# Water Street Trailhead Project

Old Georgetown Board Meeting  
January 7, 2021

# Board Recommendations and Response

**BLUESTONE STEPS**

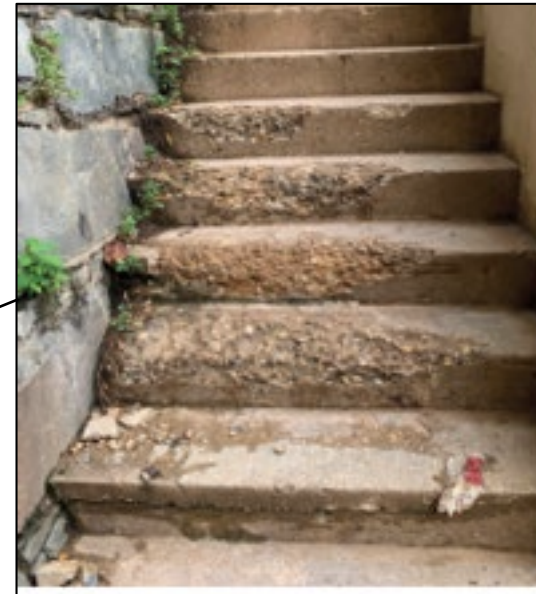
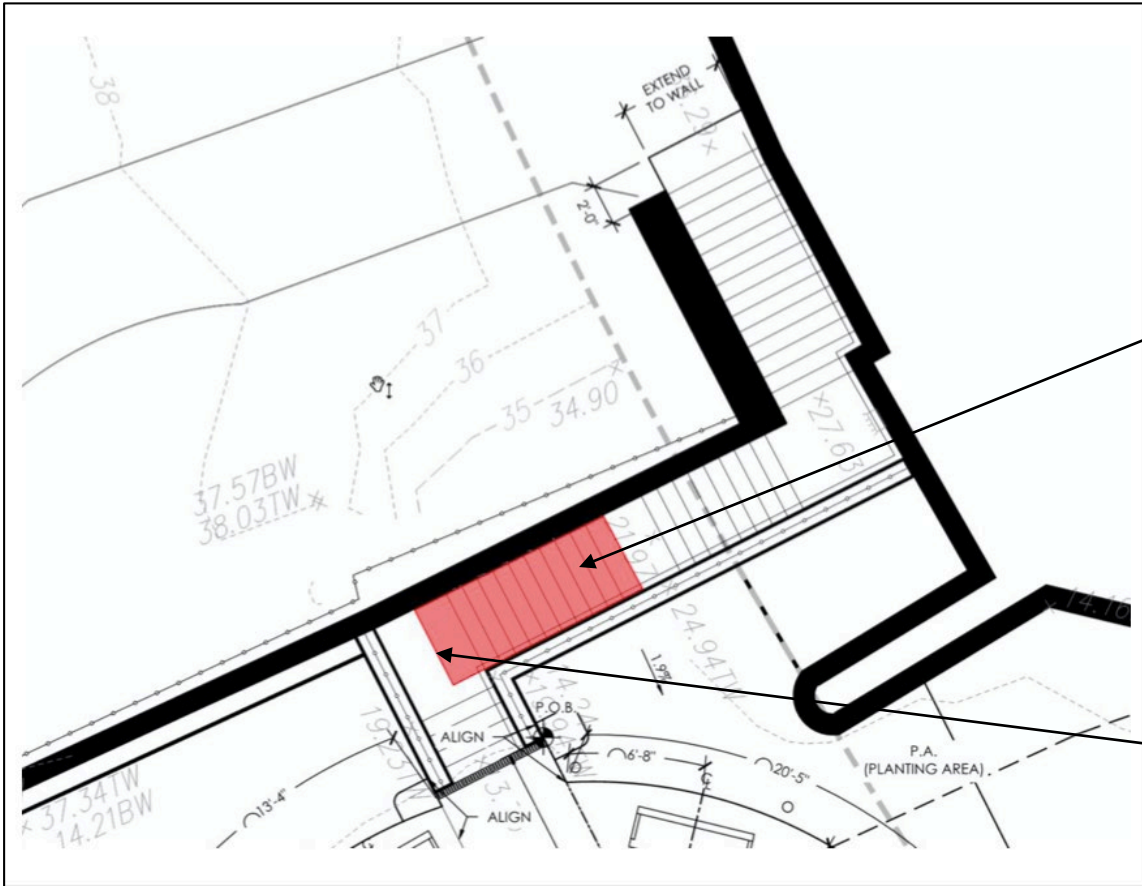
- November 5, 2020 meeting - Old Georgetown Board recommended repairing concrete steps rather than cladding with bluestone
- In response, the BID conducted site visit with concrete and masonry experts to explore:
  - Concrete repair to the most damaged portion only
  - Complete demolition and replacement of stairs
  - Bluestone cladding on stairs
  - Granite cladding on stairs
  - No repairs
- Considerations:
  - Impacts to adjacent historic stone wall
  - Lifespan of repairs
  - Aesthetic of repairs
  - Financial feasibility within the grant budget

## Preferred option

Bluestone cladding as originally proposed.

Custom cut bluestone allows more control of the joint against the stone wall.

1. EXISTING CONCRETE STAIRS TO HAVE ANY LOOSE OR FRACTURED CONCRETE MATERIAL REMOVED.
2. EXISTING STEPS TO BE POWER WASHED AND DEBRIS FREE PRIOR TO REPAIR AND INSTALLATION OF CLADDING.
